Proposal of modifications for PCS receiver function

(Detail description for comments to draft 1.1)

Seiji Kozaki, Mitsubishi Electric Corporation

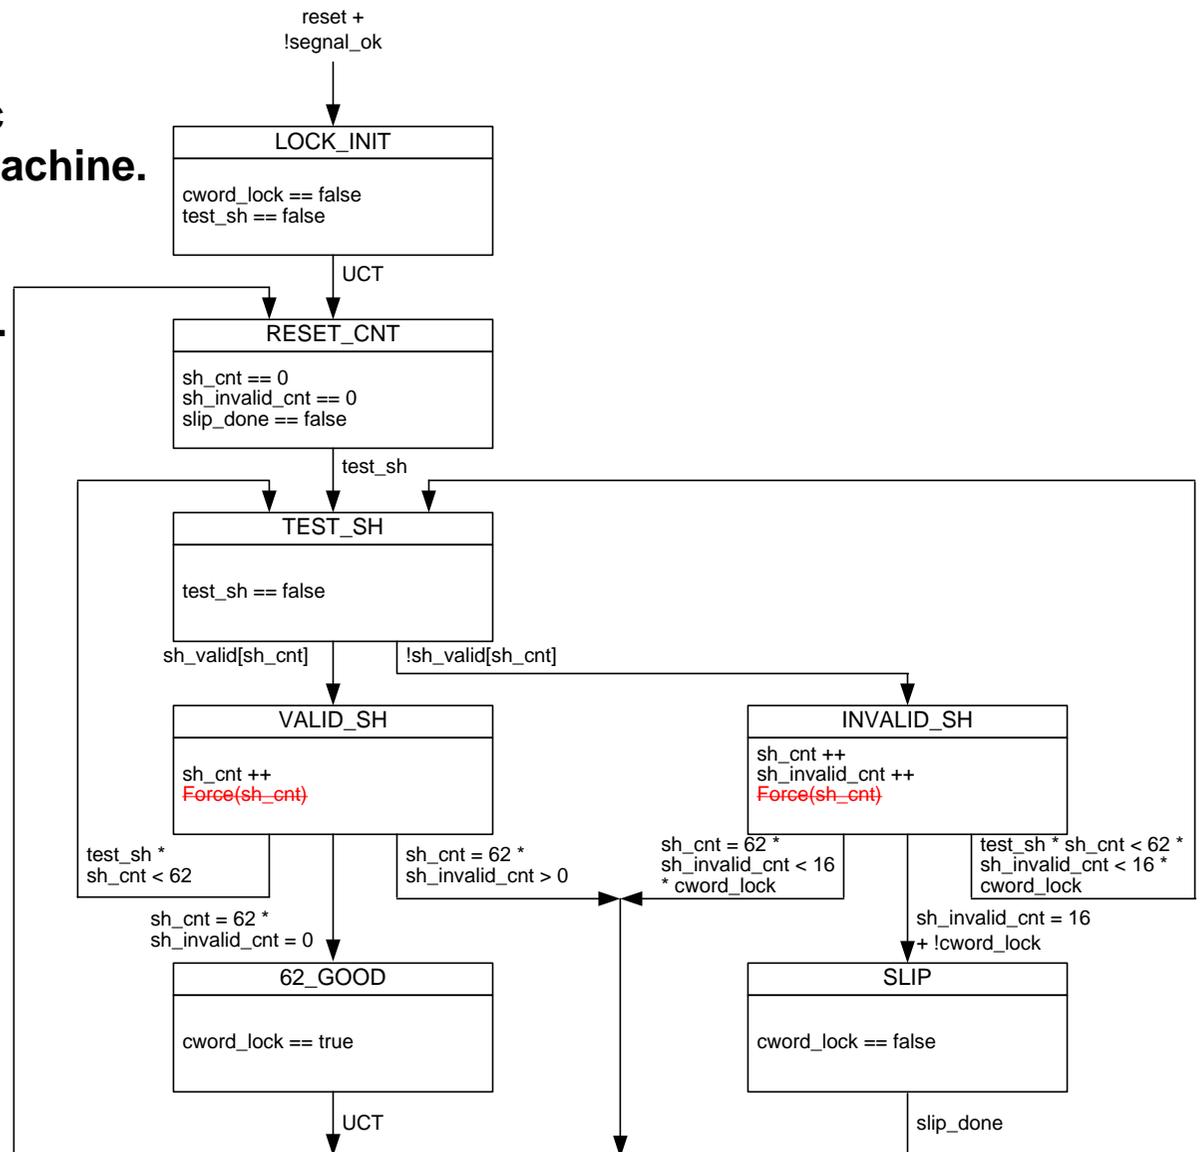
But, forcing the sync header

a) For lock state machine : It has no concerns.

The state machine always checks new sync header before forced by the function.

b) For FEC decoder : There are 2 possible merits. But actually no meaning.

i) To show FEC frame timing

(forcing the last sync header pattern to “11”)

-> Not necessary. It decreases implement choices.

ii) To improve FEC decoding characteristics (output BER).

-> Not effective. The reasons are as follow.

If there are no effects, “raw” data is better than forced data, isn't it ?

1. Remove the function of forcing sync header in the operation of lock state machine.
(as shown by right figure)

2. Remove the 4th sentence in 92.2.4.1.
(line #22 - #28)

3. Remove the sentence in 92.2.4.6.3,
corresponds to the function.
(line #37 - #54 and #1 in next page)

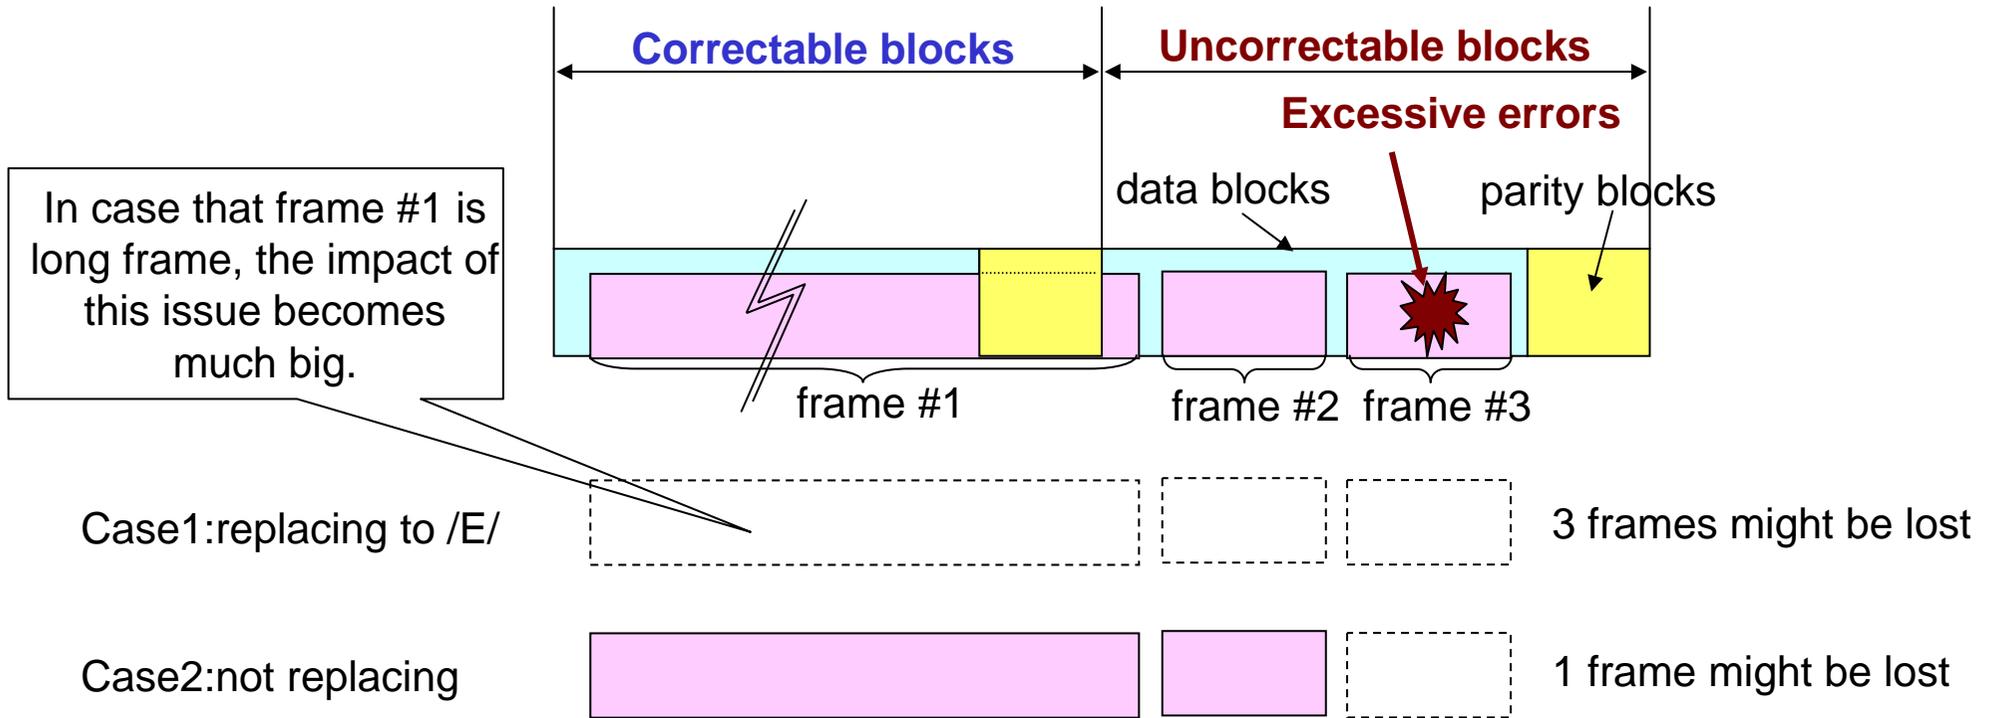
The function replacing uncorrectable blocks with /E/ blocks should not be mandatory.
 In case shown as below, 2 correct frames might be discarded.

Change "must" into "might"

The replacing function to be optional
